Re: Runway 18/36 Reconstruction and Taxiway Improvements
Mitchell Municipal Airport
Mitchell, South Dakota
AIP #3-46-0037-035-2026
Helms #A-7141

ADDENDUM NUMBER 1

PROJECT: Runway 18/36 Reconstruction and Taxiway Improvements
Mitchell Municipal Airport
Mitchell, South Dakota
DGR Project No. 731501

ADDENDUM NO. 1

FAA CONDUIT & CABLE ADJUSTMENT DETAIL
NOT TO SCALE

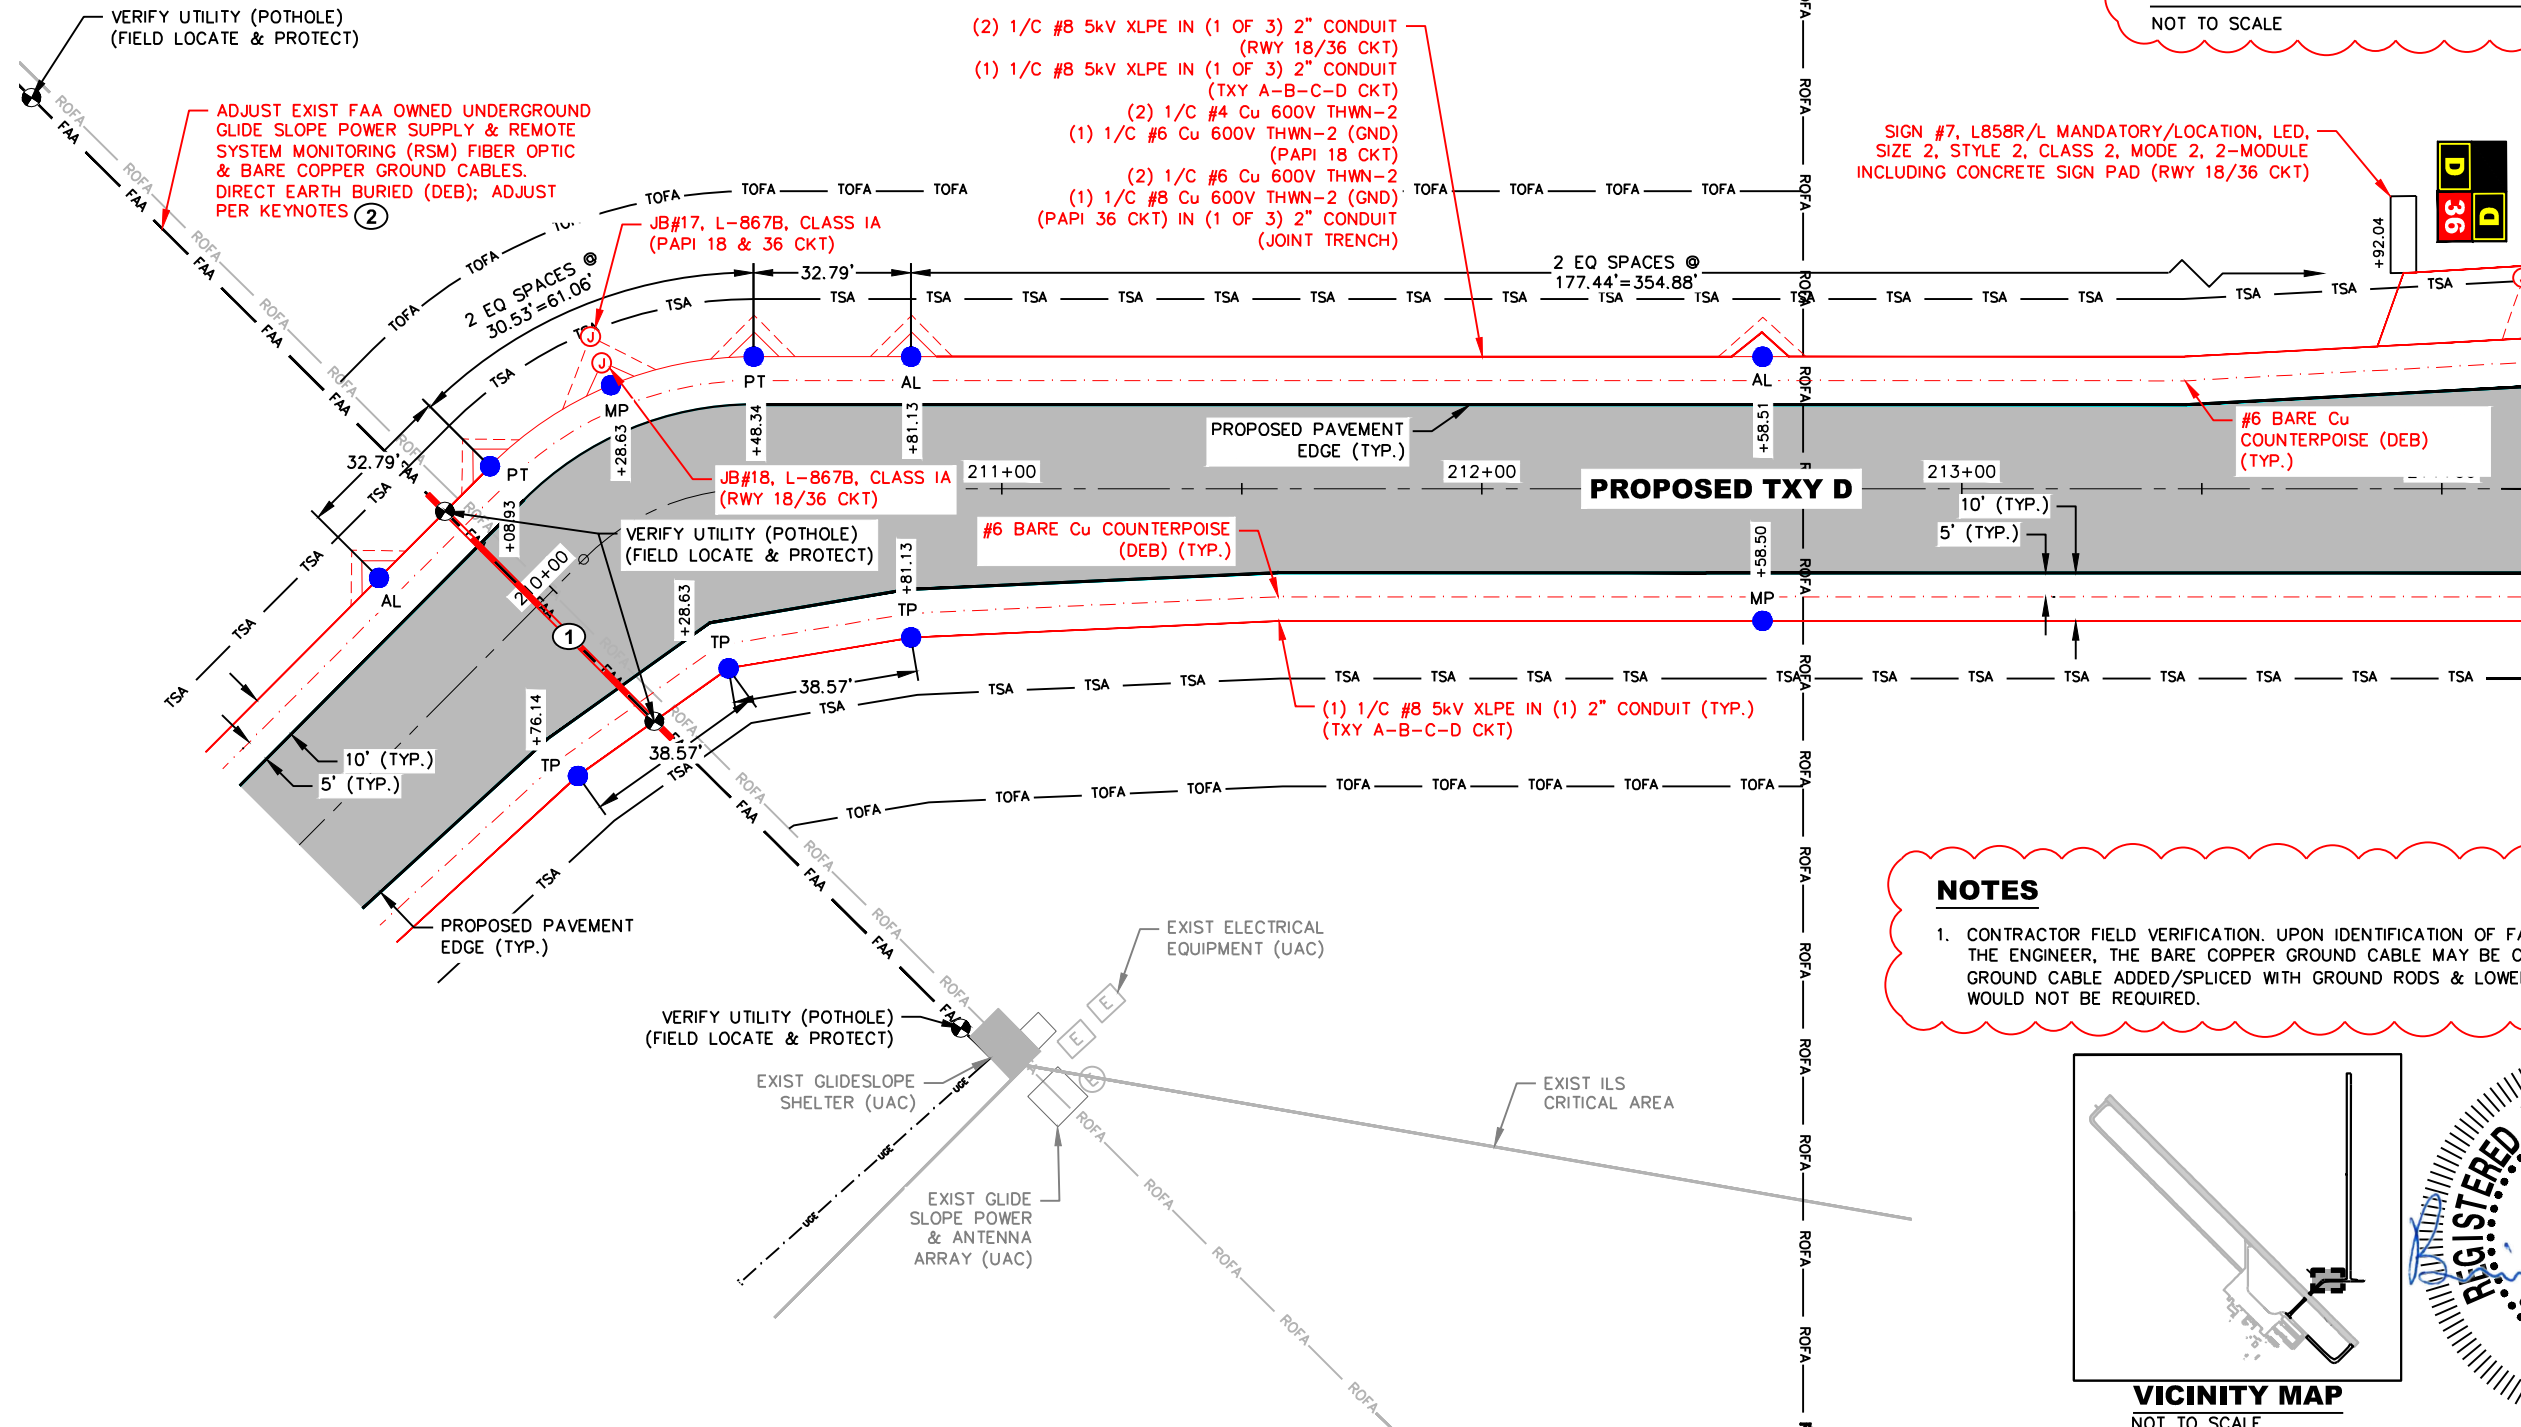
1. REPLACE the following plan sheets with the attached: E2, E30, and E37.

- ① RAISE THE EXISTING DEB POWER SUPPLY CABLES EIGHT INCHES (8") TO ELEV 1298.5. INSTALL CABLES WITHIN ONE OF THREE NEW 2-INCH SCH. 80 SPLIT CONDUITS, AND ENCASE IN SAND. (GLIDE SLOPE POWER CKT) (UNDERDRAIN CONFLICT)

- ① LOWER THE EXISTING DEB FIBER OPTIC CABLES EIGHT INCHES (8") TO ELEV 1298.5. INSTALL CABLES WITHIN ONE OF THREE NEW 2-INCH SCH. 80 SPLIT CONDUITS, AND ENCASE IN SAND. (GLIDE SLOPE FO CKT) (GRADING CONFLICT)

- ① LOWER THE EXISTING DEB BARE COPPER GROUND CABLE EIGHT INCHES (8") TO ELEV 1299.5. INSTALL CABLES WITHIN ONE OF THREE NEW 2-INCH SCH. 80 SPLIT CONDUITS, AND ENCASE IN SAND. CAP WITH MIN. FOUR INCHES OF CONCRETE. (GLIDE SLOPE GROUND CKT) (GRADING CONFLICT)

- ② VERIFY DEPTH VIA POTHOLE PER ITEM 02 01 00. MACHINE EXCAVATING PERMITTED AFTER VERIFICATION TO WITHIN 12" OF CABLES. REMAINING 12" OF EXCAVATION SHALL BE VIA VACUUM EXCAVATION OR COMPARABLE NON-DESTRUCTIVE METHOD APPROVED BY ENGINEER.

- 1. CONTRACTOR FIELD VERIFICATION. UPON IDENTIFICATION OF FAA CIRCUITS & APPROVAL FROM THE ENGINEER, THE BARE COPPER GROUND CABLE MAY BE CUT. ADDITIONAL, BARE COPPER GROUND CABLE ADDED/SPLICED WITH GROUND RODS & LOWERED. CONDUIT ENCASEMENT WOULD NOT BE REQUIRED.
